PLANNING COMMISSION
SITE PLAN VARIANCE REQUEST REVIEW SHEET

CASE NUMBER: SP-2013-0295DS **PC DATE:** 10/28/2014

PROJECT NAME: 2908 Scenic Drive (Tram)

SUBJECT: 2908 Scenic Dr. SP-2013-0295DS

View of proposed tram route

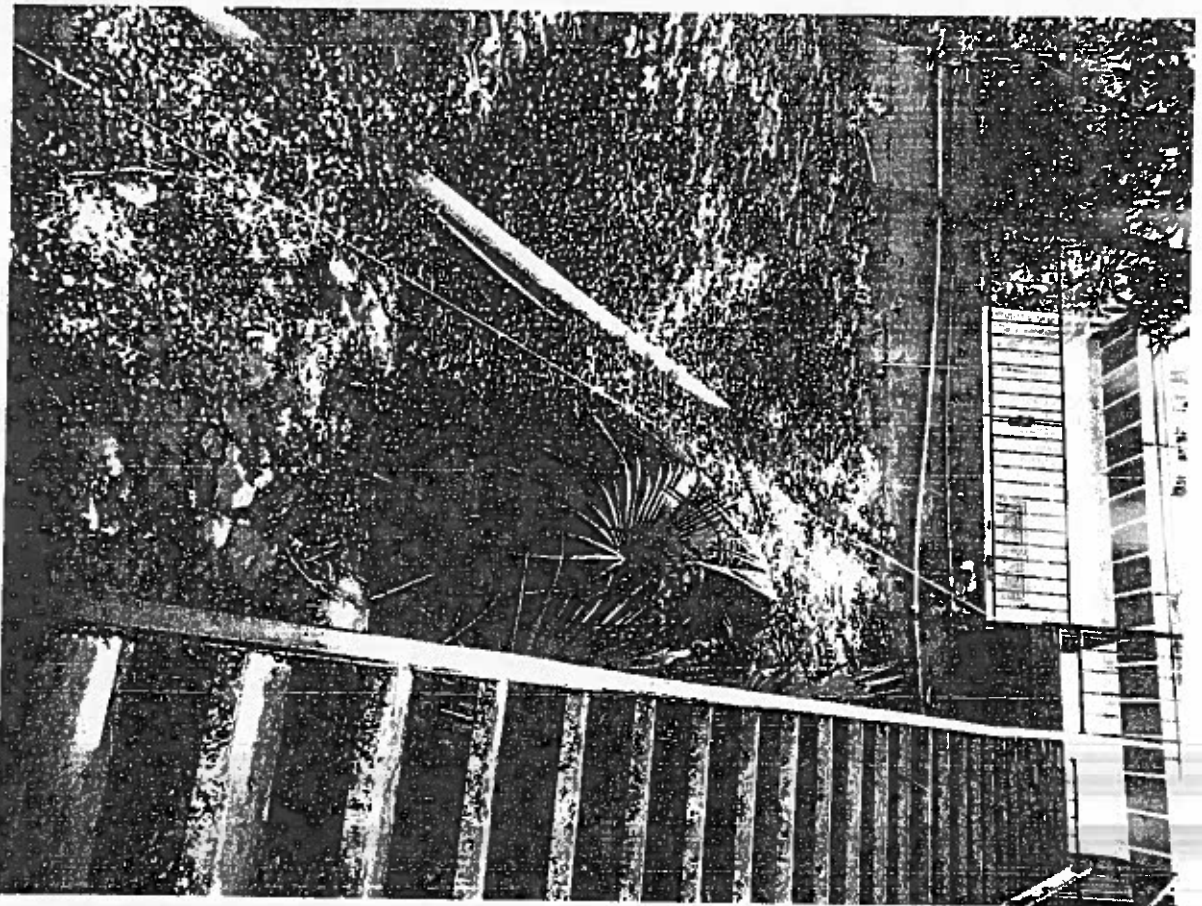
CEF at proposed tram crossing
